March 29, 1996

Proposed ROD Amendment

Gould Superfund Site

Portland, Oregon

Figure 1

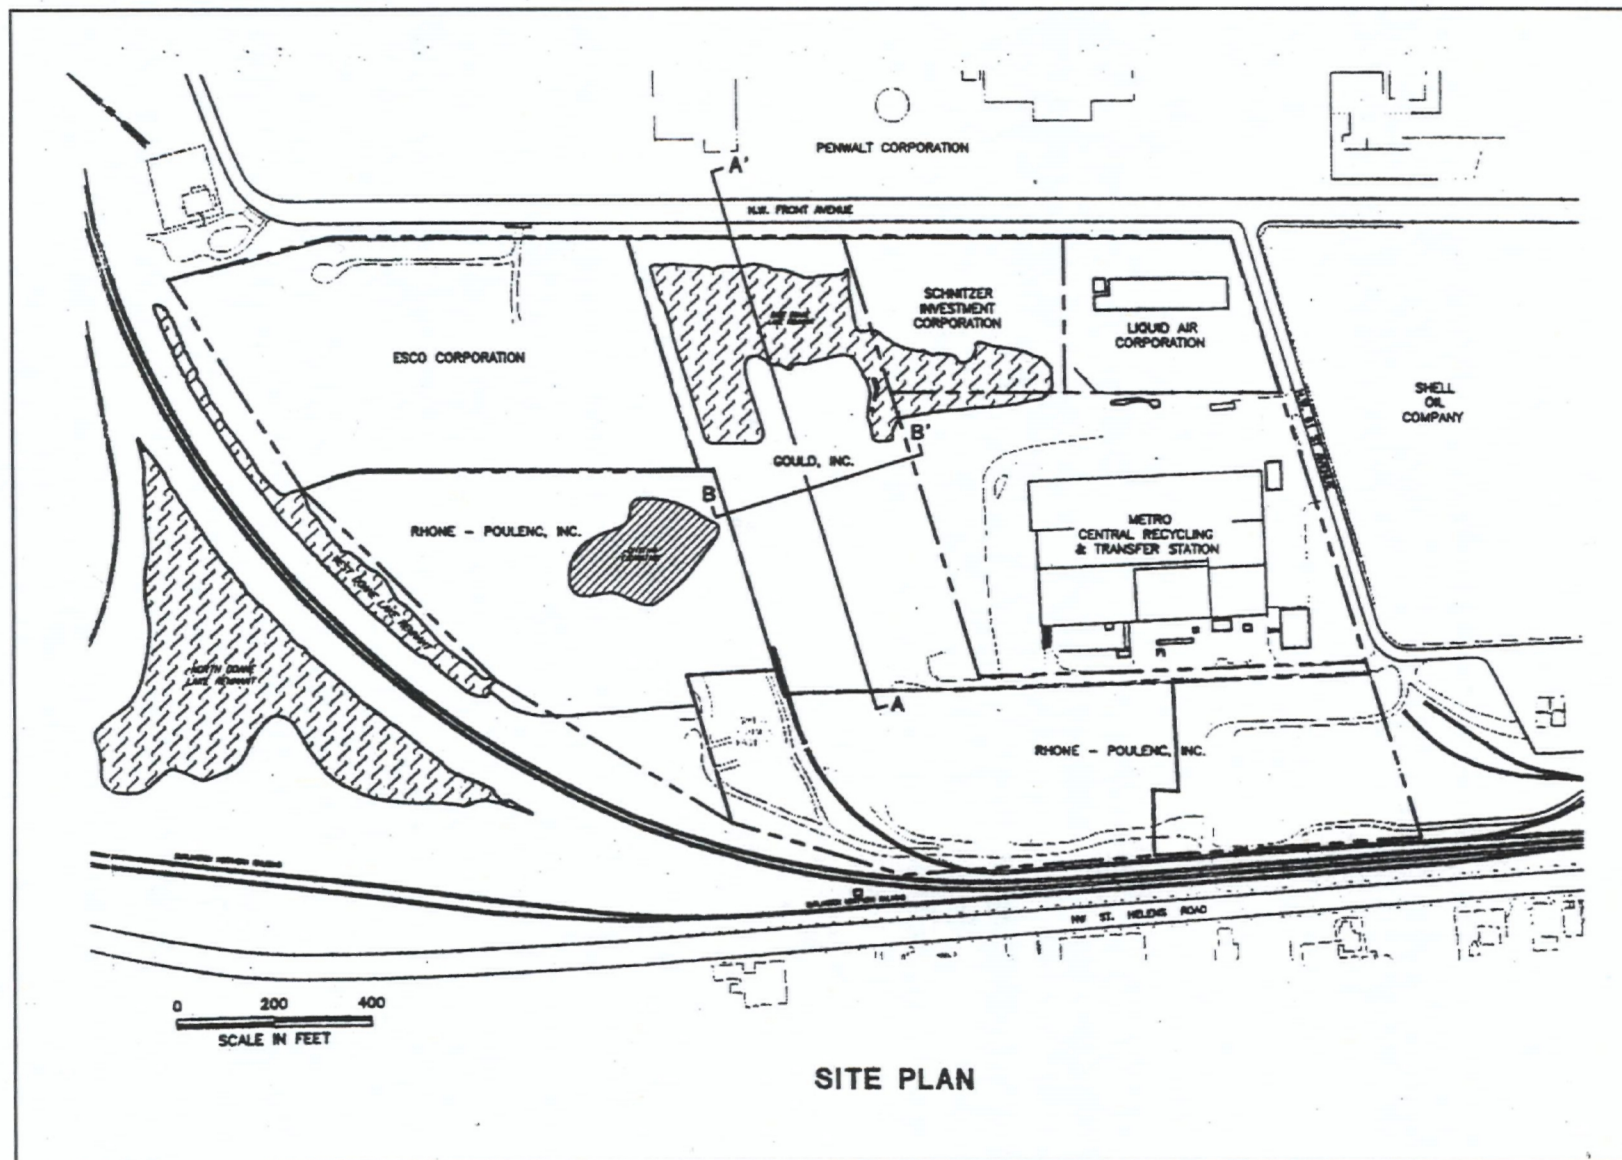
4) The East Doane Lake remnant will be filled to provide additional surface area for construction of the on-site containment facility, to eliminate surface pathways of exposure, and to allow future use of the property.

The proposed remedy includes excavation of the remaining battery casings on the Gould property portion of the site; dredging and de-watering of sediments from the East Doane Lake remnant; and containing the sediments, stockpiled materials (including previously treated materials and shallow soils and debris) in a lined and capped on-site containment facility on the Gould property. The proposed facility will cover most of Gould property, up to approximately 8.5 acres, including the area now within the East Doane Lake remnant (see Figure 1). This proposed remedy will allow future industrial use of the Gould property.

Figure 2

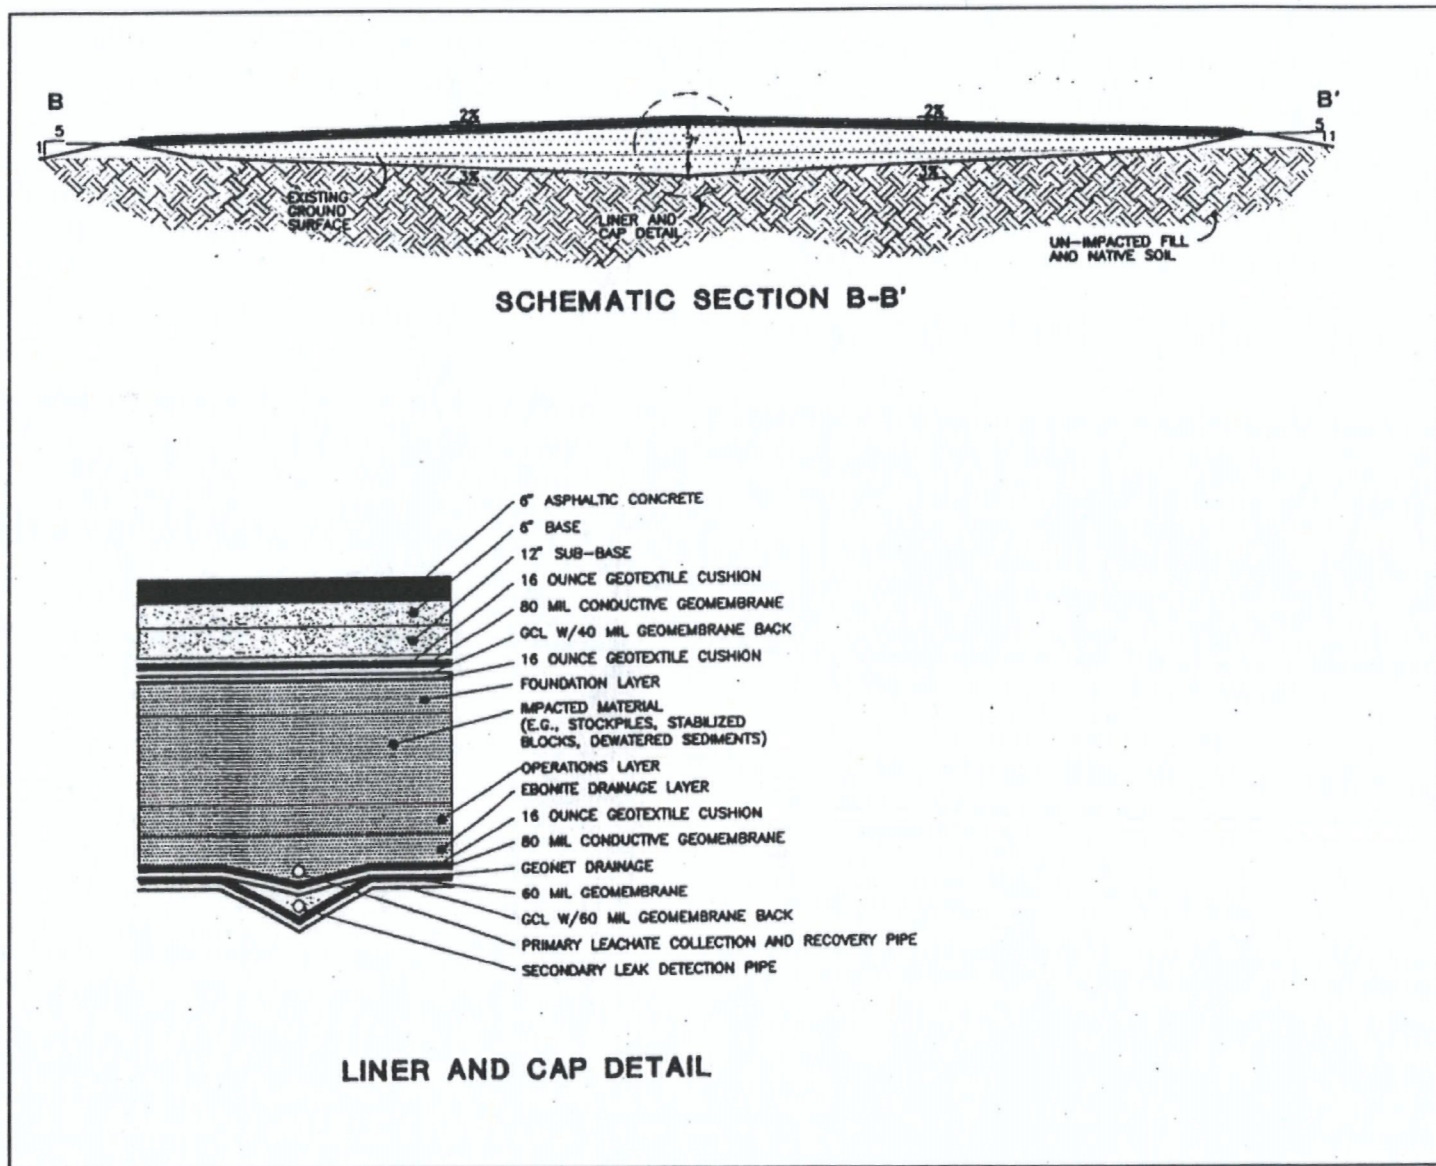
When completed, the containment facility will hold approximately 60,000 cubic yards of contaminated waste material, sediment, soil, and debris. It will have a total thickness of approximately eight feet, including bottom liner, waste and impacted soil, cap system, and asphalt surface. A cross section of the containment facility is presented in Figure 2.
